GRANDVIEW RESERVE FILING NO. 1

EARLY GRADING & EROSION CONTROL PLANS

EL PASO COUNTY FILING NO: PUDSP-21-10

G1.01

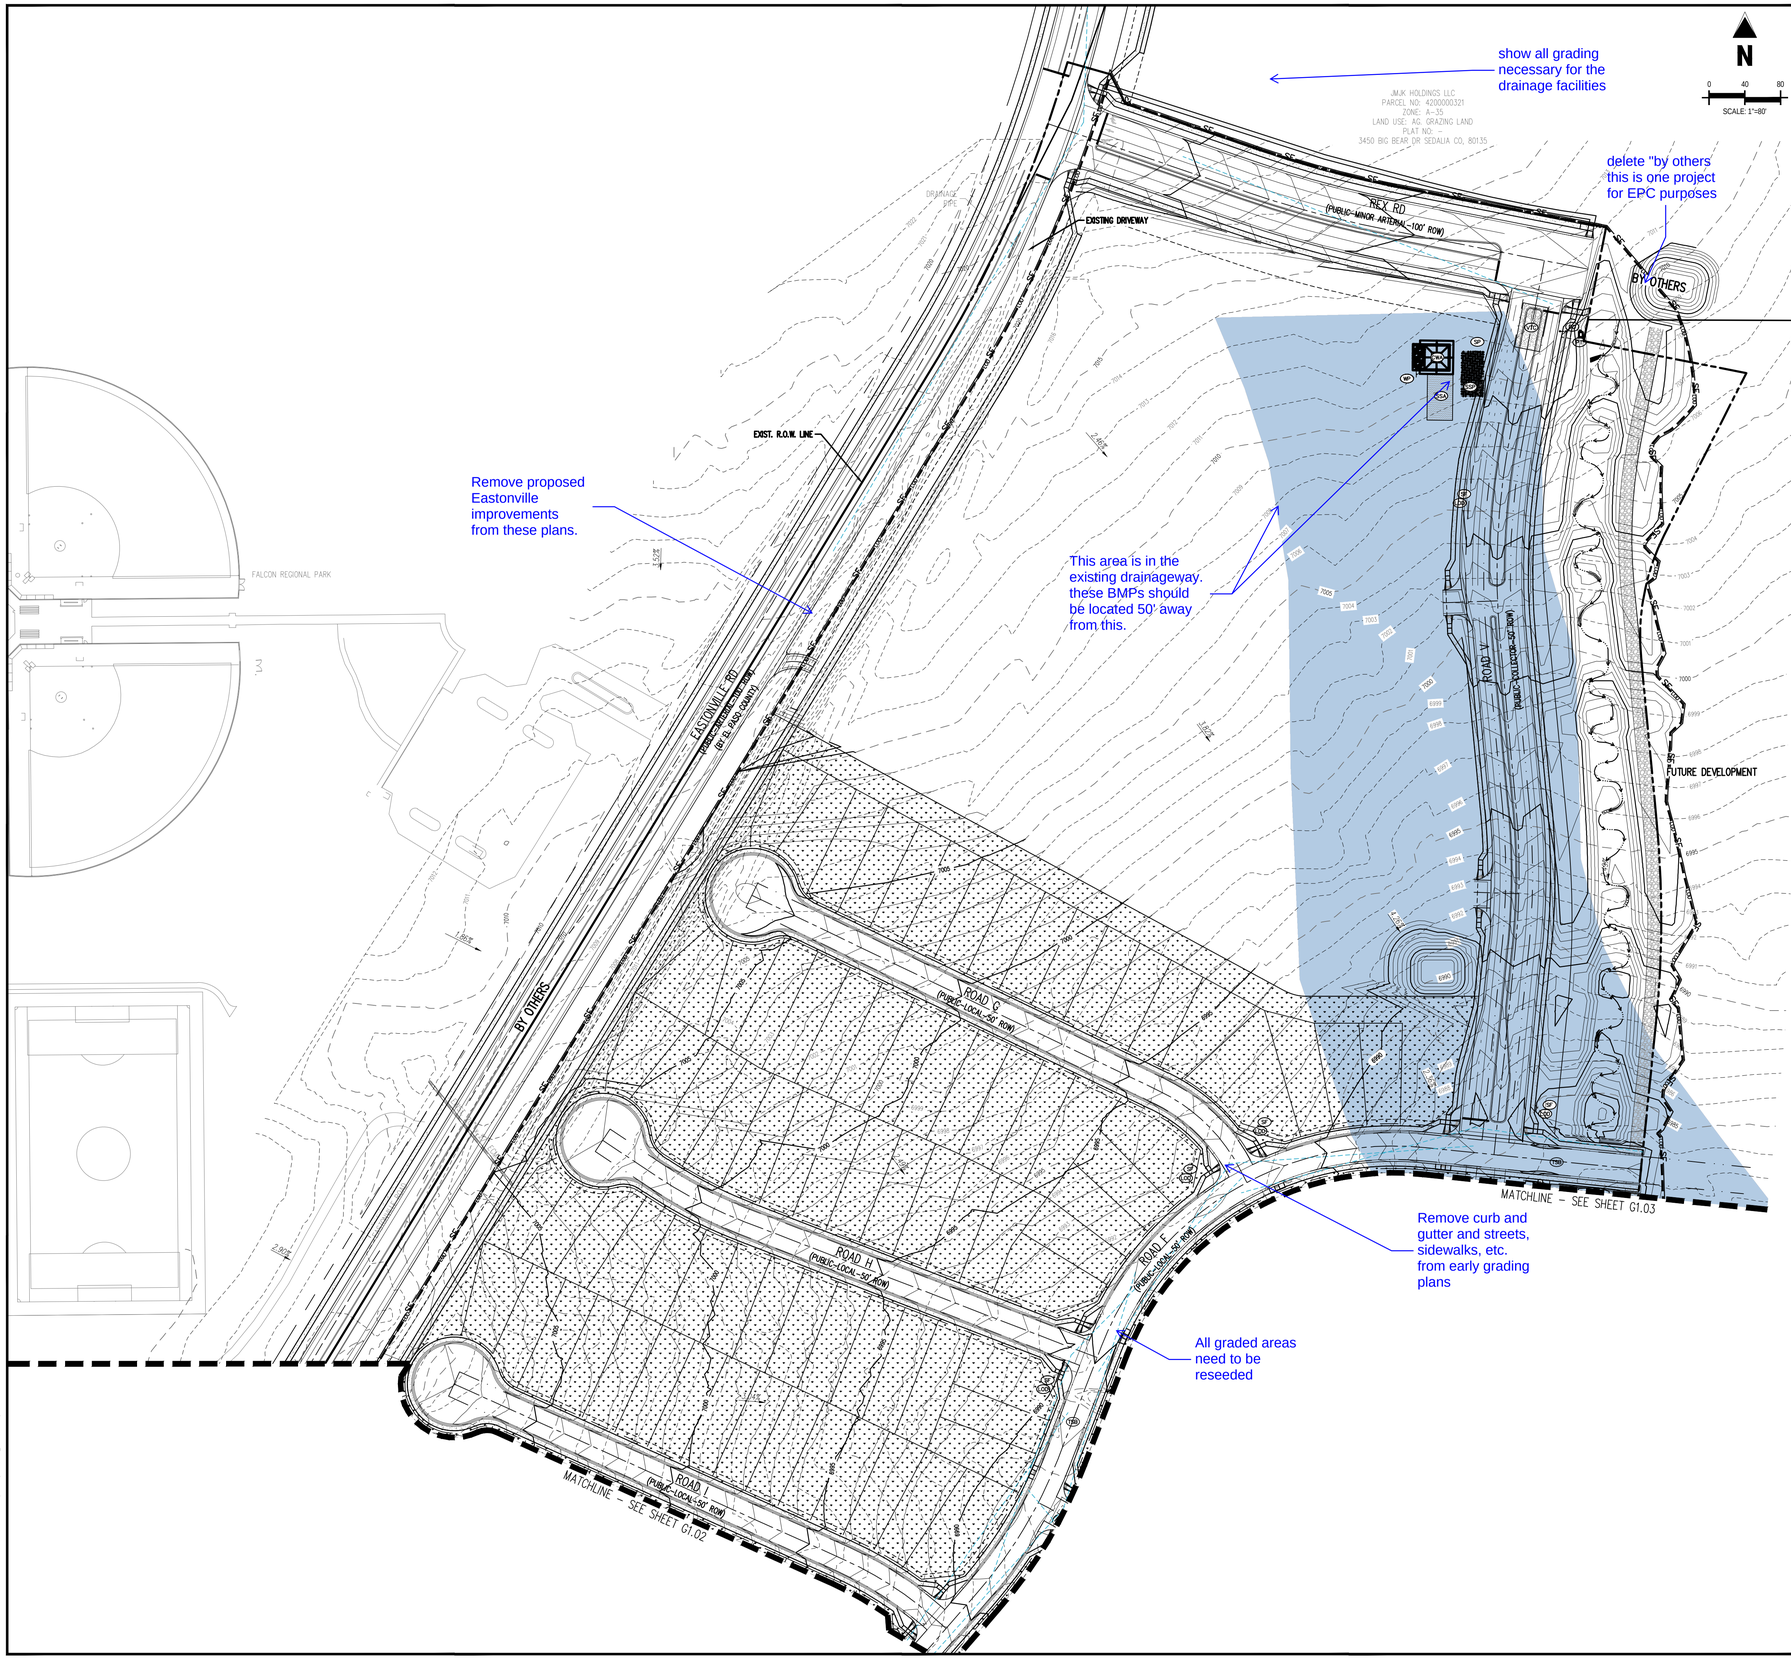
Retaining walls need details. They shouldn't be constructed with early grading

G1.03

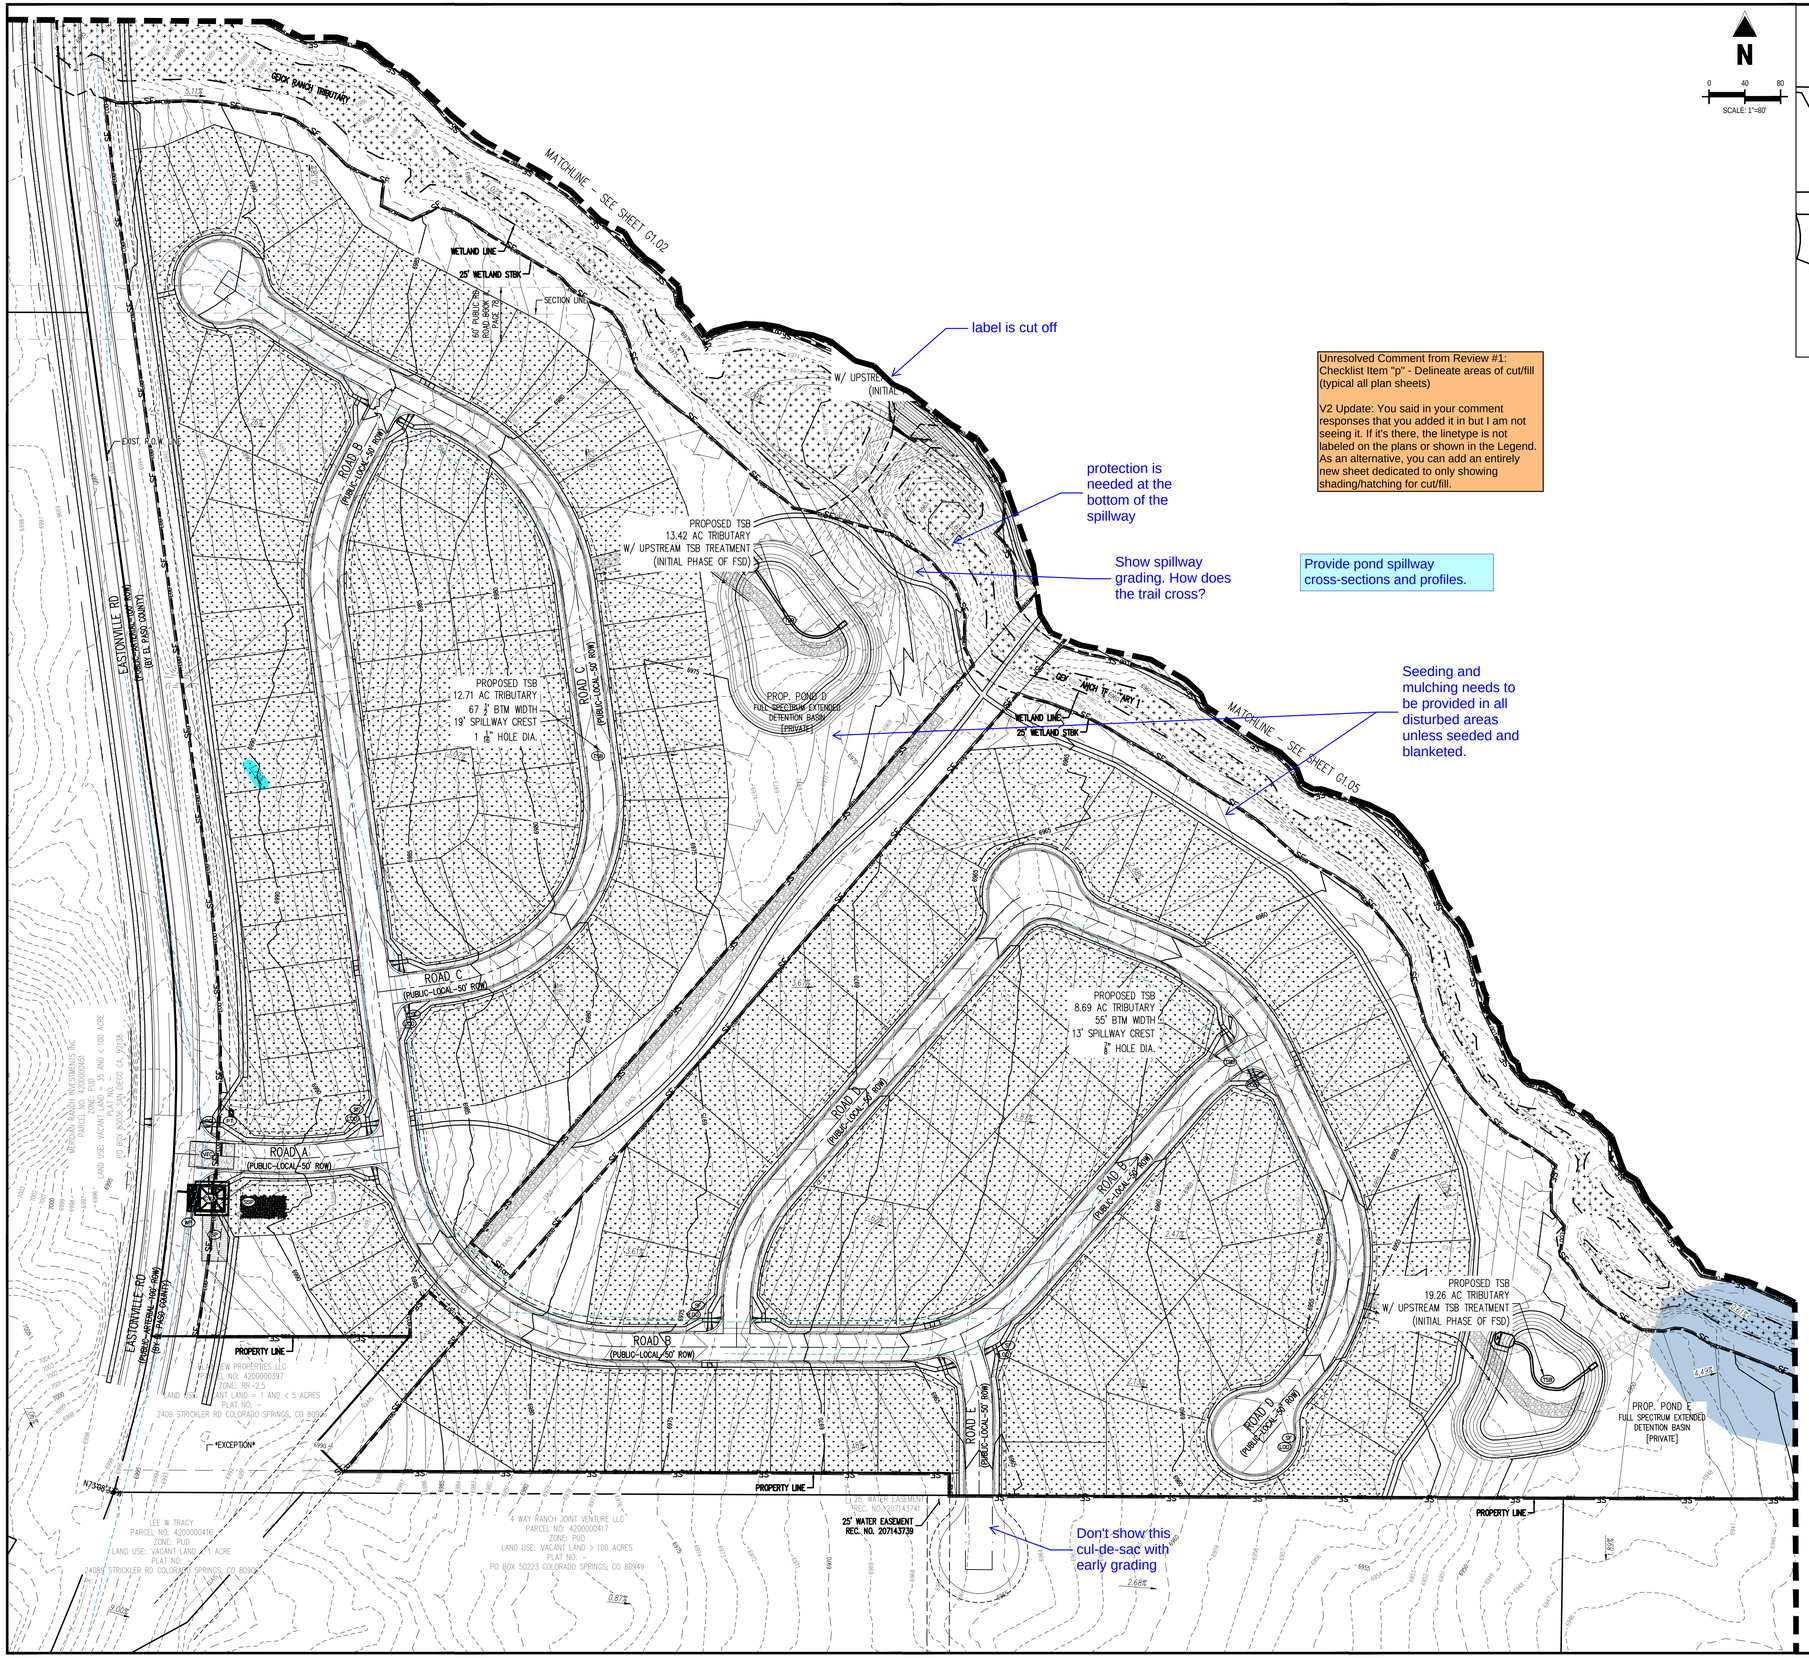
Unresolved Comment from Review #1: Checklist Item "p" - Delineate areas of cut/fill (typical all plan sheets)

V2 Update: You said in your comment responses that you added it in but I am not seeing it. If it's there, the linetype is not labeled on the plans or shown in the Legend. As an alternative, you can add an entirely new sheet dedicated to only showing shading/hatching for cut/fill.

Provide pond spillway cross-sections and profiles.

GRADING & EROSION CONTROL PLAN

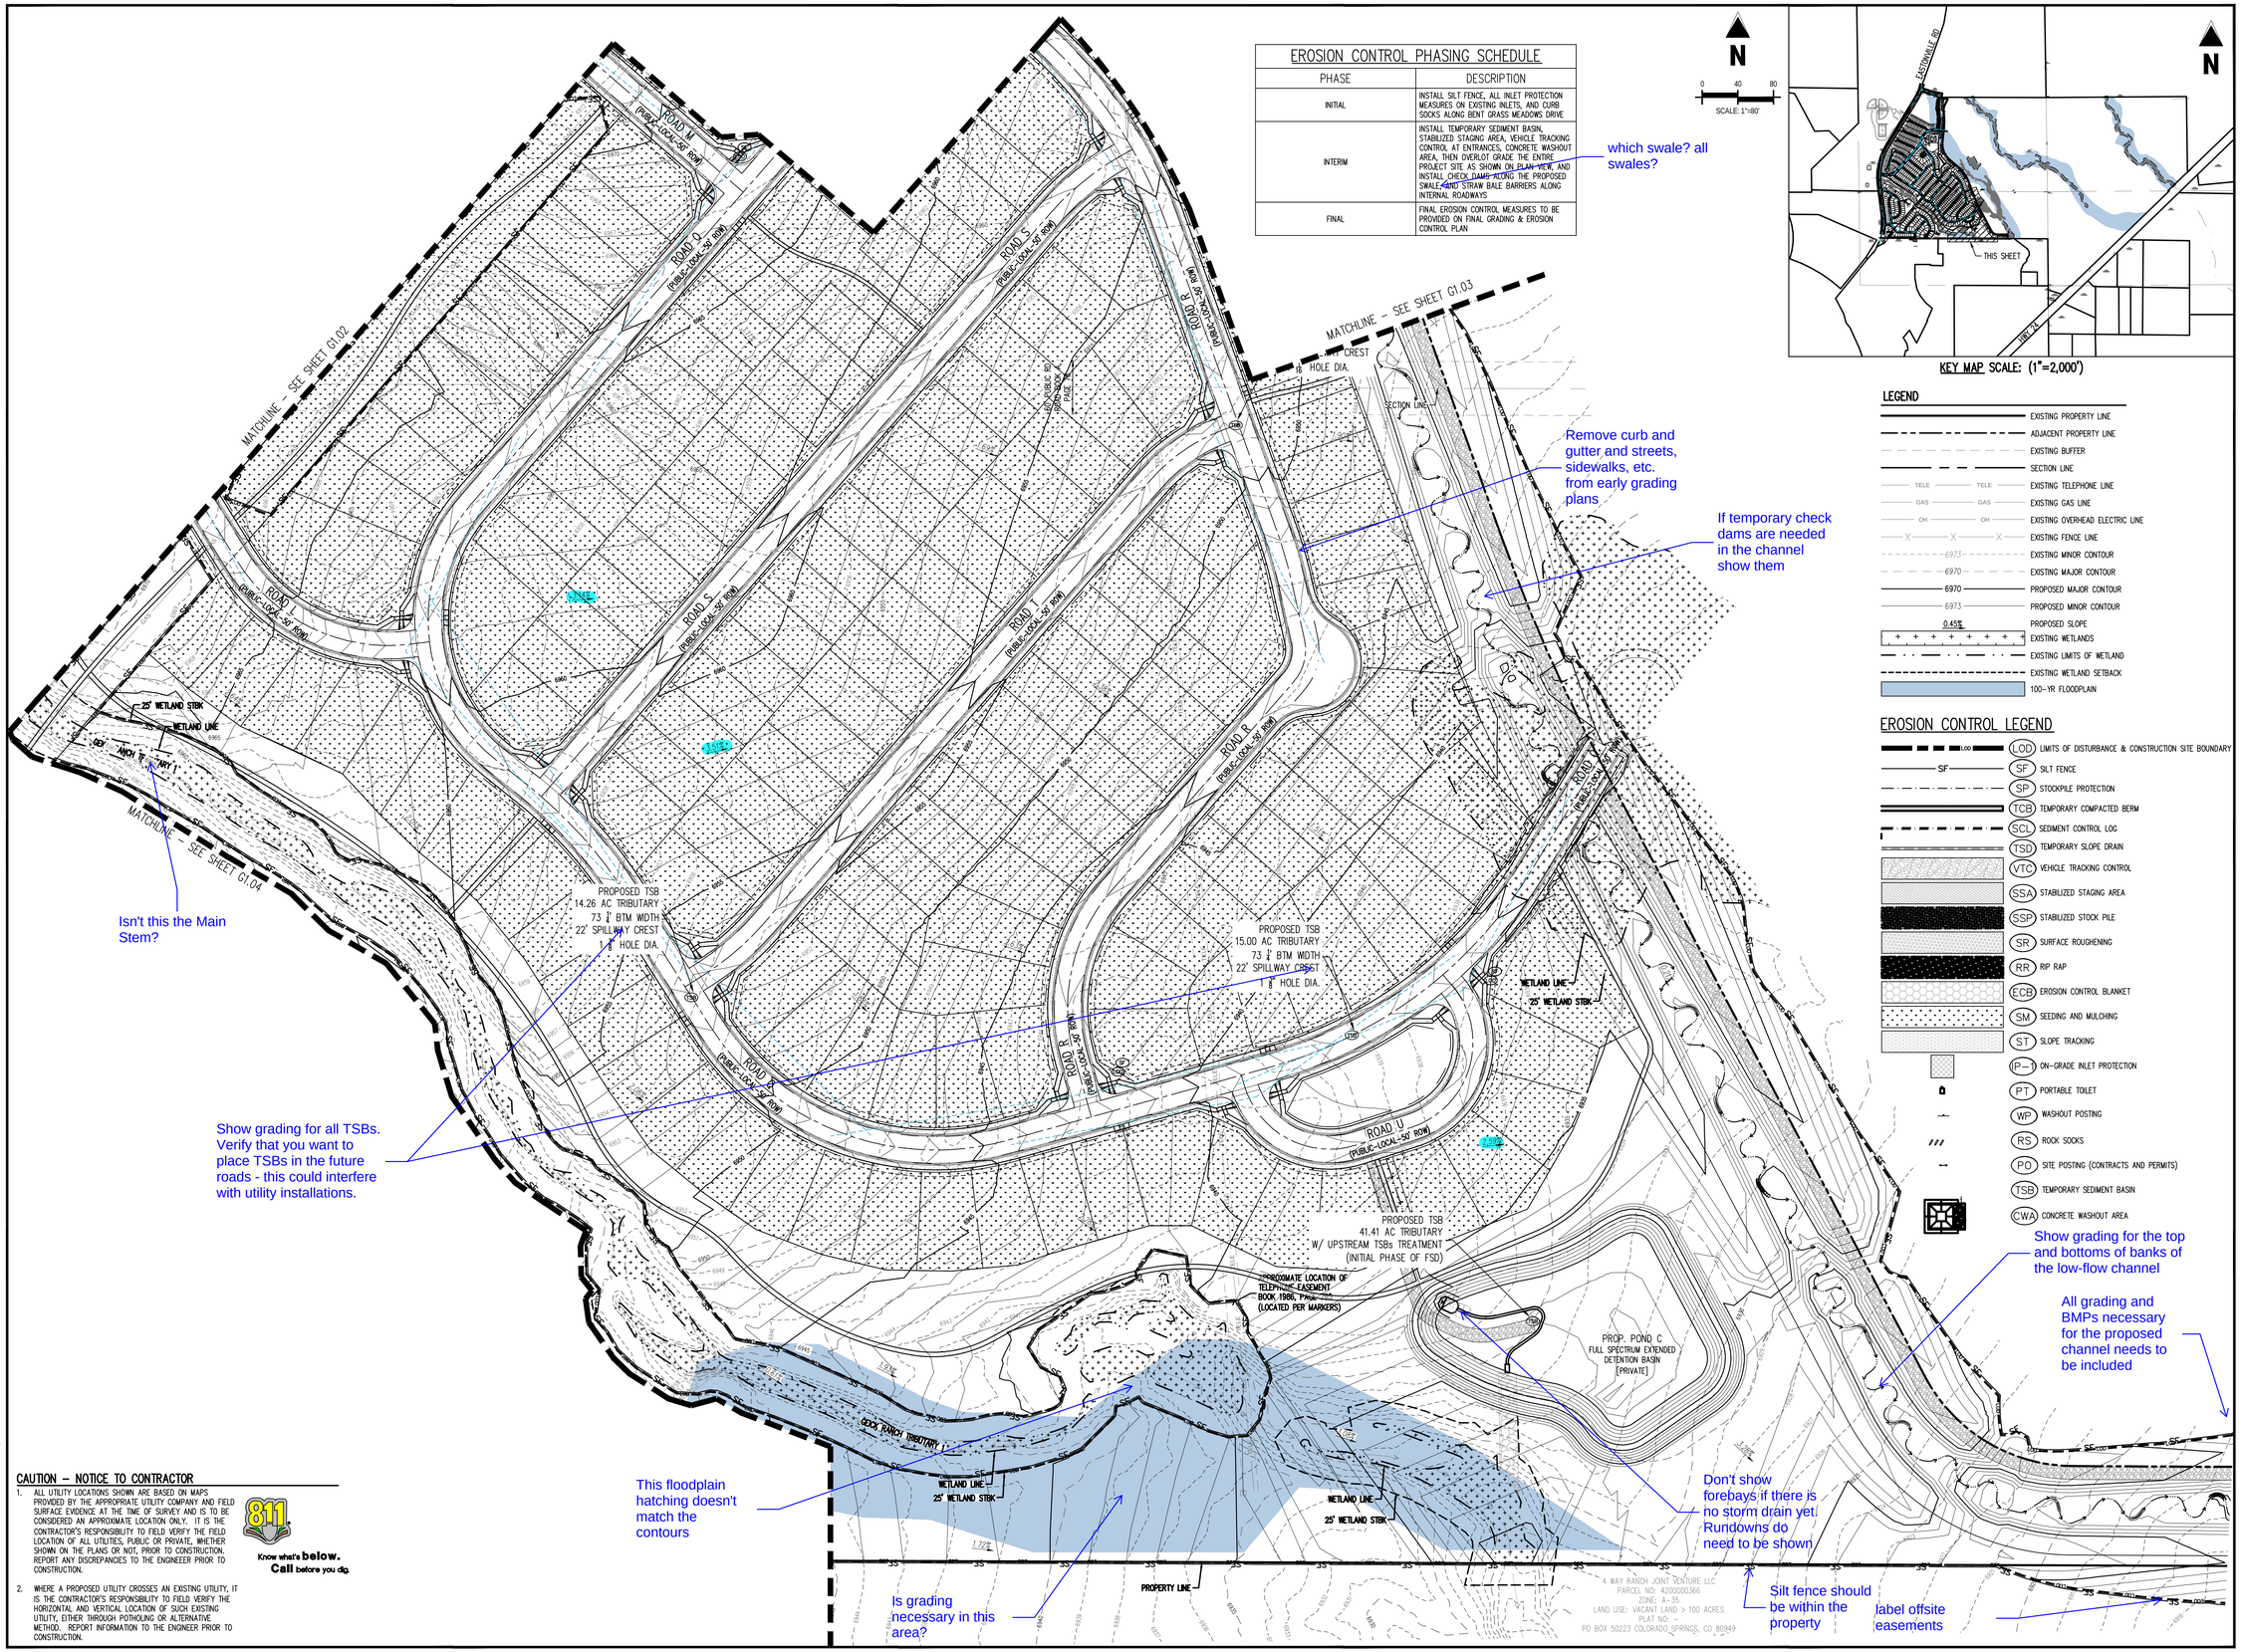
Remove curb and gutter and streets, sidewalks, etc. from early grading plans

If temporary check dams are needed in the channel show them

Show grading for all TSBs. Verify that you want to place TSBs in the future roads - this could interfere with utility installations.

Show grading for the top and bottoms of banks of the low-flow channel

Don't show forebays if there is no storm drain yet. Rundowns do need to be shown

Silt fence should be within the property

label offsite easements

Sheet 8 of 14

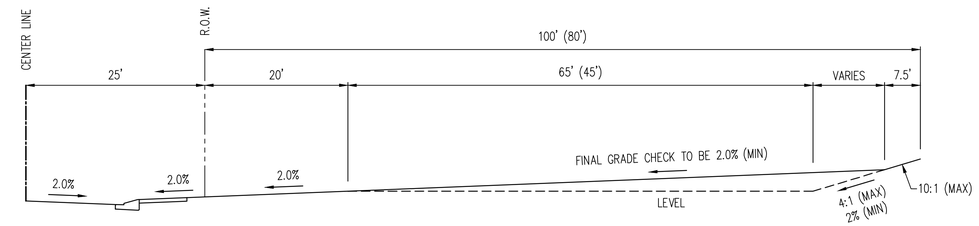
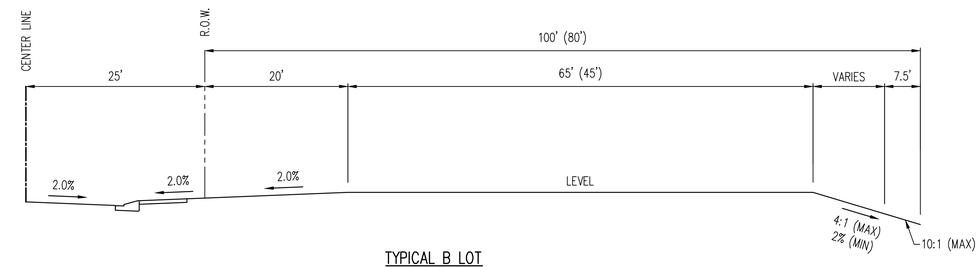
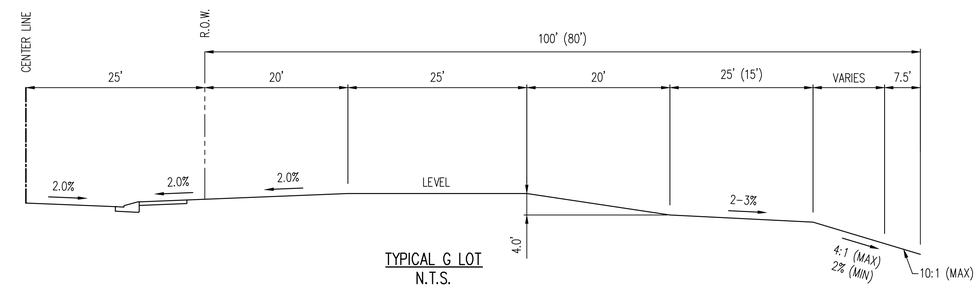
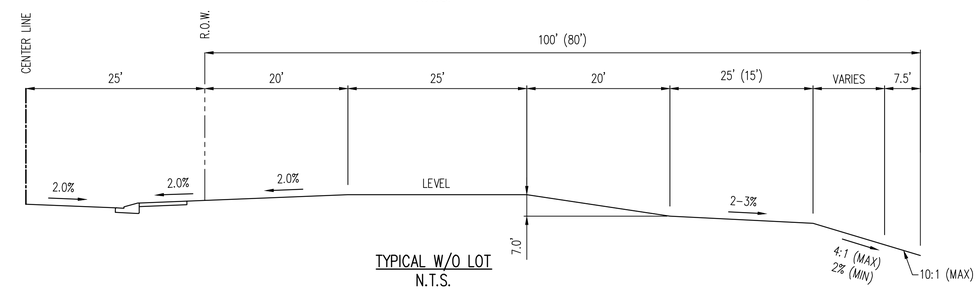
Provide channel cross-sections and details
